Architect: Snyder Architects Inc.	Date: 2024-10-22
Attention: Amit Patel, Anil Gokarn, Avinash Garde, Mike Wilding, Jamie Leach, Shakil Manashiya, Jake Graham	Project: Gymnasium Addition at Glenview PS
Subcontractor: Kirk Mechanical	Shop Drawings – Mechanical –FAN-R1

## Shop Drawing Submittal

# Grilles/Registers/Diffusers Submittals

**93 Steel Gymnasium Grille – 45° Deflection, 1/2" Blade Spacing**

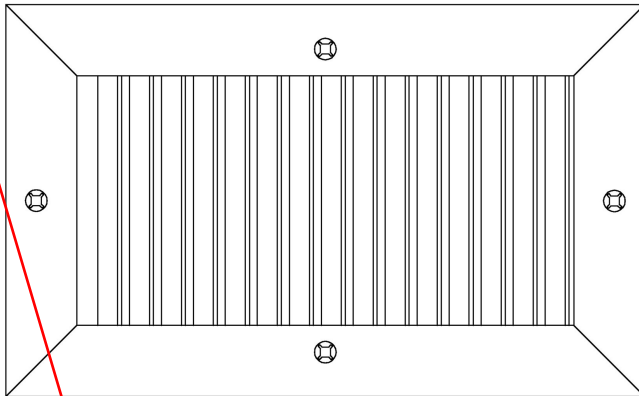
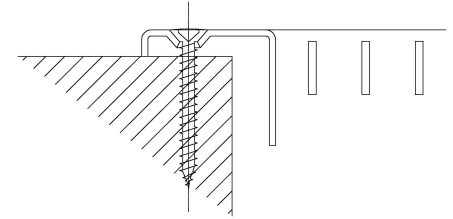
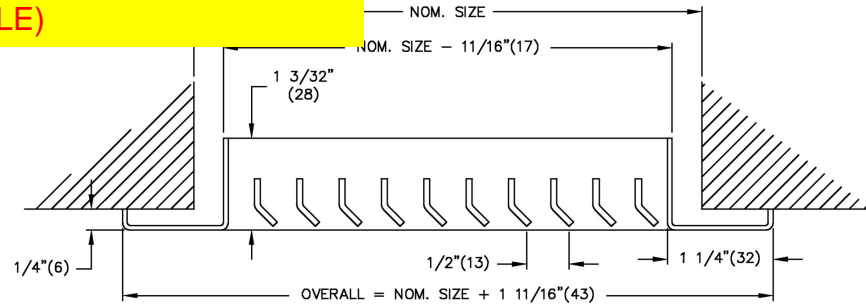
**PROVIDE 91 SERIES, HEAVY DUTY (3/8" SPACING WILL BE ACCEPTABLE)**

**PROVIDE HORIZONTAL FRONT BLADES**

| <input type="checkbox"/> Not Reviewed | <input checked="" type="checkbox"/> Revise and Resubmit |
